Consumers
Power
Company

DOCKET 50-155, LICENSE DPR-6 -
BIG ROCK POINT PLANT - T/S CHANGE
REQUEST - DRY OUT TIME LIMITS

CONSUMERS POWER COMPANY
Docket 50-155
Request for Change to the Technical Specifications
License DPR-6

Figure 1
 FUNCTION $T(Q)$ FOR ENC 11X11 FUEL
 POWER VOID RELATION

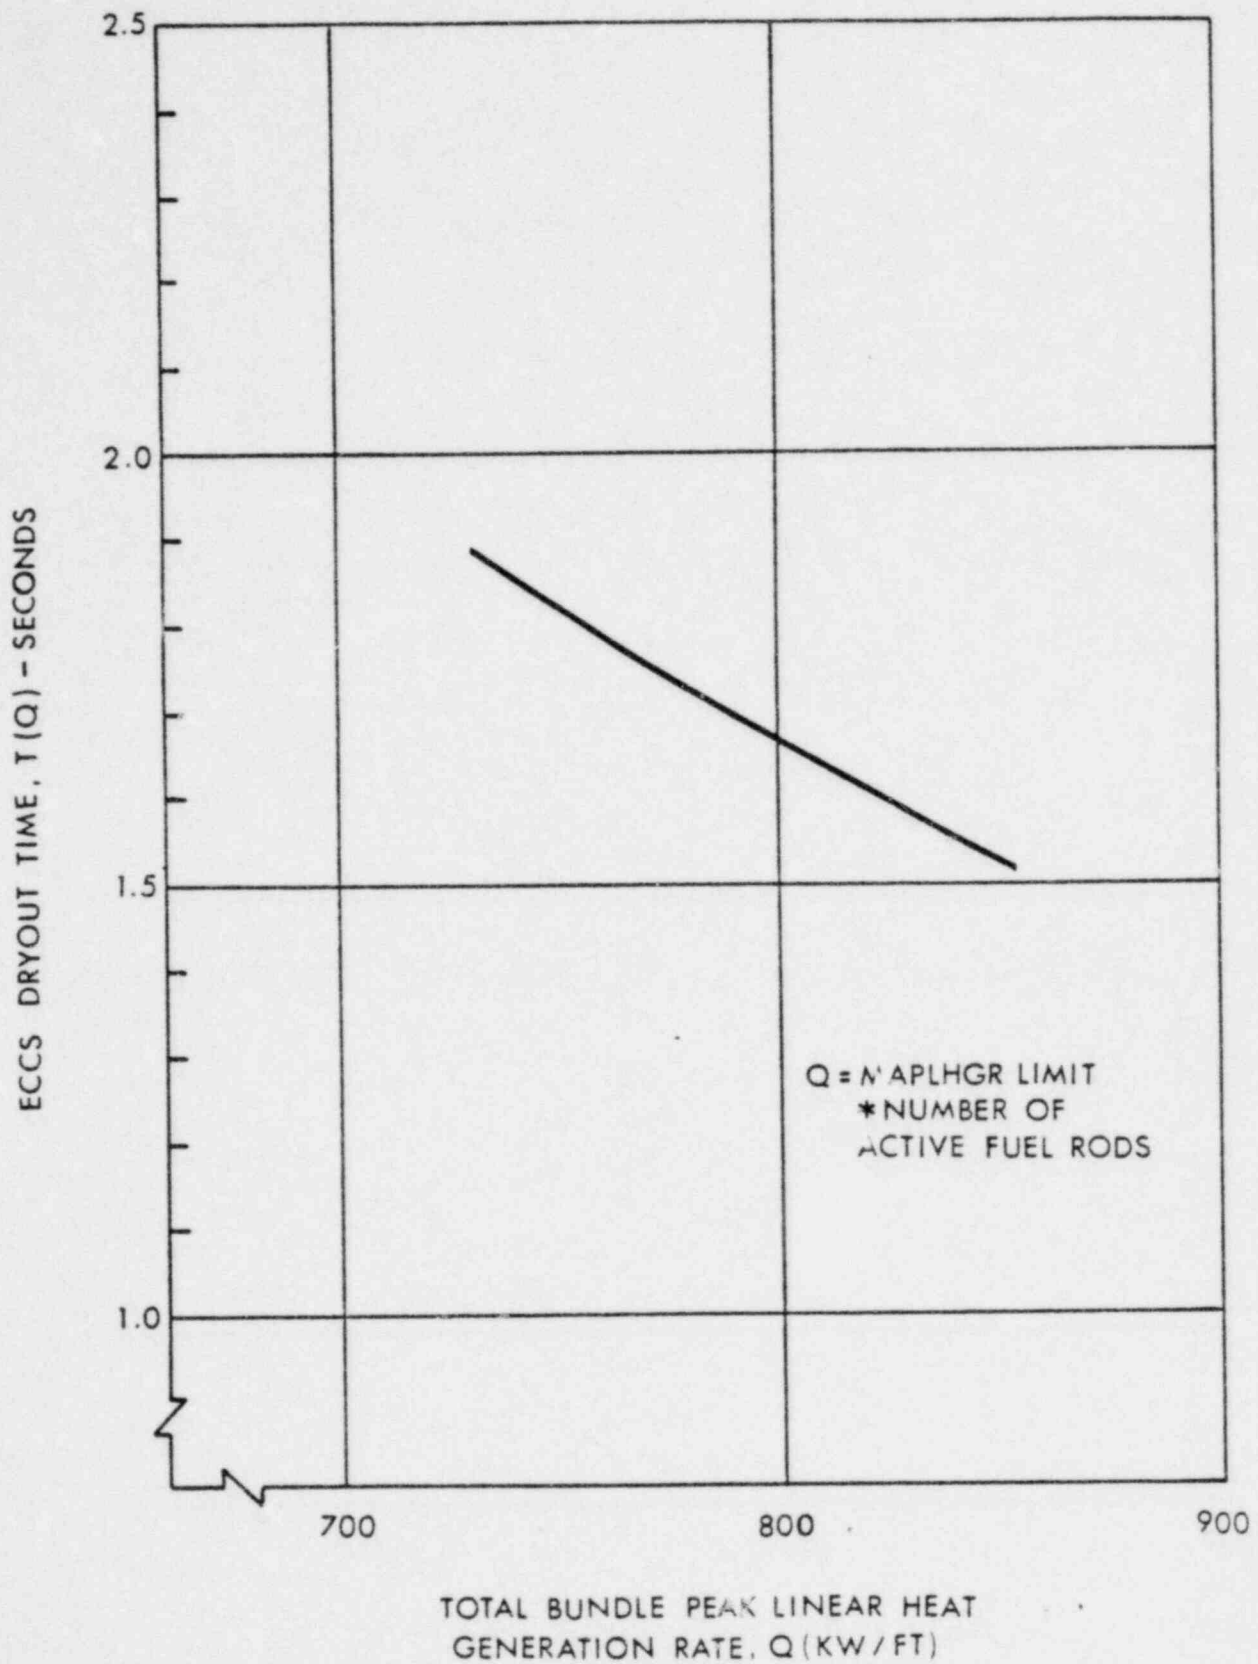
C. Add new Figures 1 and 2 after Table 2.

subcooling and the coolant flow rate. The parameter $T(Q)$ is the dry out time used in the ECCS heatup analysis as a function of total bundle peak linear heat generation rate Q . Q is equal to the MAPLHGR limit times the number of active fuel rods in the assembly. The function $T(Q)$ is given in Figure 1 for ENC fuel and in Figure 2 for GE fuel.

During power operation, the assembly average void fraction and assembly power for ENC 11 x 11 and GE 9 x 9 fuel shall be such that the following relationship is satisfied:

$$\text{Actual Dry Out Time} \geq T(Q)$$
